SECOND GENERATION DISTRICT PLAN

Variation 2 – Additional Housing Capacity Part 3 – Sites Proposed for Rezoning

Evidence on 3 Waters

TO:	Bede Morrissey, Policy Planner, City Development
FROM:	Jared Oliver, Engineering Services Team Leader, DCC 3 Waters Group
DATE:	29 th June 2022
SUBJECT:	VARIATION 2: 3 WATERS RESPONSE TO REQUEST FOR COMMENTS ON DCC-PROPOSED GREENFIELD SITES

Figure 3: Structure Plan for Site

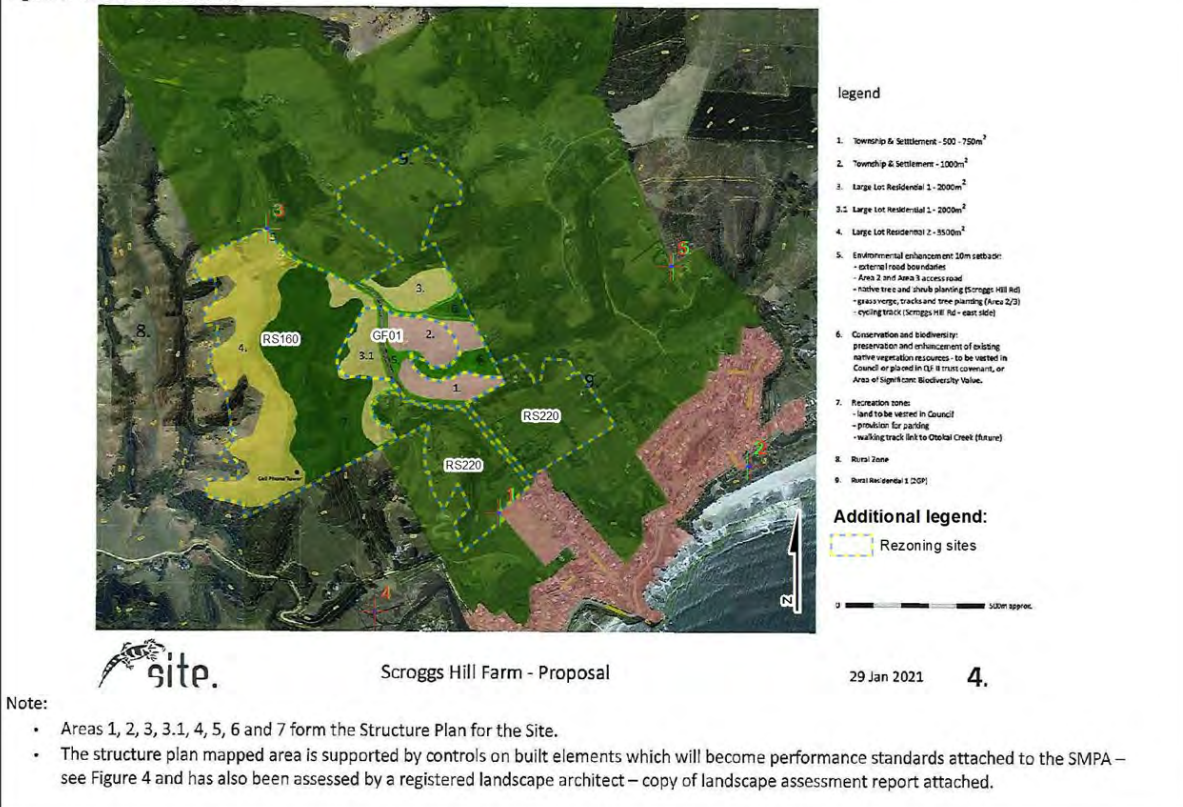
- The proposed Structure Plan requests a range of zoning, including:
 - Township and Settlement – at site sizes of 500-750m²
 - Township and Settlement – at site sizes of 1,000m²
 - Large Lot Residential 1 – 2,000m²
 - Large Lot Residential 2 – 3,500m²
- Submitters have requested rezoning of RS220 to either Large Lot Residential 1 or Township & Settlement. For the purposes of this assessment Township & Settlement zoning of RS220 was assumed.
- It is estimated that across the whole assessed area this would result in a yield of up to 200 lots.
- The 3 Waters infrastructure assessment of the proposed structure plan detailed in Submission S249 plus RS220 is summarised in the table below.

development as per the proposed Structure Plan is not currently supported.
Potable Water Supply	Significant issues (manageable)	The site elevation varies from approximately 116m to 6m. The site location is outside the area that is currently serviced by DCC. However, the Brighton Reservoir is within the site location at an elevation of approximately 86m. This is fed by Southern WTP, elevation approximately 114m. The existing infrastructure is adequate to service a portion of the proposed development at lower elevations. The topography of the site suggests that an additional reservoir would be required to service higher elevation areas of the site (to the north of the site) up to an approximate elevation of 84m (therefore the RS220 site but no further). Booster pumps and pressure reducing valves would be required to service any areas at higher elevation than approximately 84m. Dunedin's water supply is fortunate in many areas to not require pumping. 3 Waters prefers gravity to pumping where possible due to lower operating and maintenance costs and supporting DCC's Zero Carbon policy. I do not support servicing water supply for development above 84m elevation. I believe that it may be possible to consider development up to 84m pending further detailed analysis to investigate the feasibility of the proposed reservoir. Some major upstream network upgrades would be required in the future. At this stage the proposal is not supported from a water supply perspective. Further investigation and assessment is required.

Due to the large site area, onsite attenuation would be required. The campground downstream has had previous flooding issues. Provided the stormwater management rules in GF01 were applied to the whole proposed structure plan area the site may be considered developable, however I have concerns over the affordability of the stormwater infrastructure.
--	--	---

14. The proposed structure plan has no details on whether or how the site would be serviced for water or wastewater or how stormwater would be managed for the site. It is essential that the requirement for servicing and means of 3 Waters servicing is documented. Stormwater management needs to be adequately considered, designed, and approved by DCC, and the NDMA is considered an acceptable way to ensure a holistic and appropriate approach is taken to stormwater management for the whole structure plan area.

16. The 3 Waters infrastructure assessment for the proposed Structure Plan does not support the proposal. Water supply and wastewater servicing require further investigation and stormwater management, while possible, may not be affordable.
